SUBJECT: BRAIDWOOD STATION, UNITS 1 AND 2—NRC INTEGRATED INSPECTION
REPORT 05000456/2017004; 05000457/2017004; AND EMERGENCY
PREPAREDNESS ANNUAL INSPECTION REPORT 05000456/2017501;
05000457/2017501

Report No: 05000456/2017004; 05000457/2017004;
05000456/2017501; 05000457/2017501

Facility: Braidwood Station, Units 1 and 2

Description of Circulating Water Blowdown Piping at Braidwood

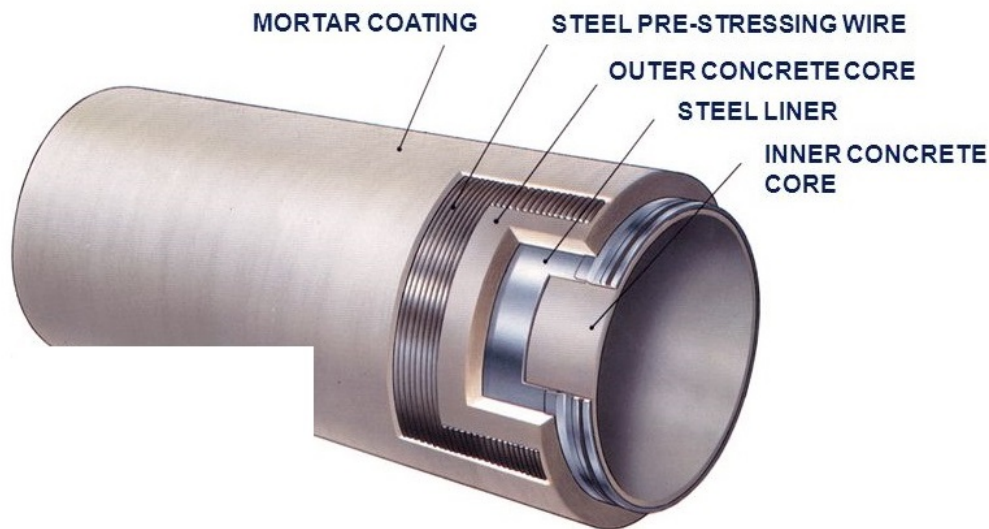
The inspectors identified weaknesses in the licensee's evaluations associated with maintaining the integrity of the CWBD piping. The NRC inspections performed during this inspection period prompted the licensee to accelerate their follow-up inspection plans. These follow-up inspections resulted in the discovery of cracks in the mortar and concrete surrounding the steel piping that were subsequently repaired. These cracks were repaired prior to any CWBD piping leakage. One finding of minor significance was identified.

Although a follow-up RFTC inspection of the CWBD piping was planned for 2018, the licensee had not identified other methods to reduce the risk of failure for the distressed pipe segments and industry guidance to reduce the risk of failure was available. For example, an EPA-sponsored study described ways to reduce the risk of failure for

In response to the inspectors' observations, the licensee elected to accelerate the schedule for the planned 2018 inspection of the CWBD piping. By December 16, 2017, the licensee, utilizing specialized services of a vendor, completed a follow-up RFTC inspection and visual examination of the interior surface of the CWBD piping. During this examination, the licensee identified one pipe segment with two internal axial cracks of the inner concrete core. The licensee excavated this pipe segment to facilitate repairs and take samples of groundwater and the soil adjacent to this pipe segment.
